Access Compliance Report

Public Rights-of-Way

(Curb Ramps)

Intersection ID: 8925	Main Street: E_W_T_HARRIS_BV	Cross Street: THE_PLAZA	Location: SE
ADA ID: 5EB0404ED60C	Ramp Type: Para	Initial Pass/Fail: Fail	Overall Compliance: No
Codes/Mitigation Info/Possible Solution			Severity Score: 12.5
			Field Measurements/Component Compliance

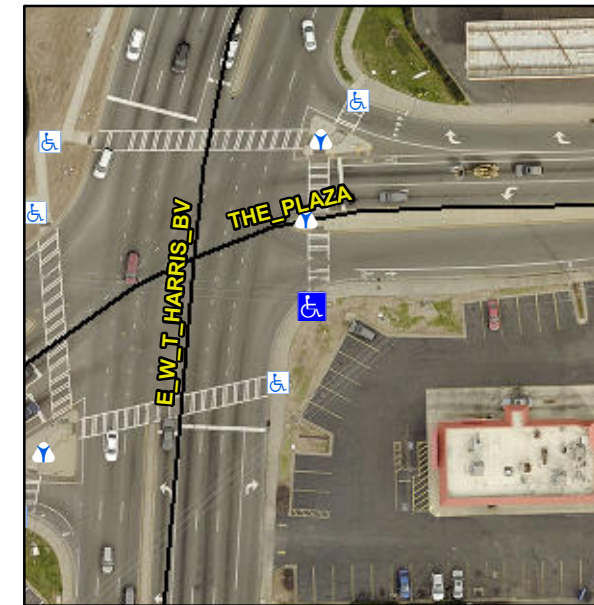
R304.3.2

Compliance	Description	Data	Compliance	Description	Data
N/A	Ramp Length LT (in)	60.0	N/A	Ramp Length RT (in)	57.0
Yes	Ramp Width LT (in)	83.5	Yes	Ramp Width RT (in)	83.5
Yes	Ramp Slope LT (%)	5.3	No	Ramp Slope RT (%)	11.3
Yes	Ramp XSlope LT (%)	1.9	Yes	Ramp XSlope RT (%)	1.4
N/A	Landing Length (in)	N/A	N/A	DWS Provided?	N/A
N/A	Landing Width (in)	N/A	N/A	DWS Contrast?	N/A
N/A	Landing Slope (%)	N/A	N/A	DWS Length (in)	N/A
N/A	Landing X Slope (%)	N/A	N/A	DWS Full Width?	N/A
N/A	Landing Curb? (Y/N)	N/A	N/A	DWS Offset (in)	N/A
N/A	Shared Landing?	N/A			
N/A	Gutter Ponding?	N/A	N/A	Gutter Slope (%)	N/A
N/A	Gutter Lip Ht (in)	0.5	N/A	Gutter X Slope (%)	N/A
N/A	Painted X Walk1?	Yes	N/A	Painted X Walk2?	N/A
	X Walk 1 Direction	To N		X Walk 2 Direction	N/A
N/A	X Walk 1 Width (in)	111.5	N/A	X Walk 2 Width (in)	N/A
	X Walk 1 Slope (%)	2.4		X Walk 2 Slope (%)	N/A
	X Walk 1 X Slope (%)	1.7		X Walk 2 X Slope (%)	N/A
N/A	Ramp inside XWalk1?	Yes	N/A	Ramp inside XWalk2?	N/A

Remove & Replace Entire Ramp.
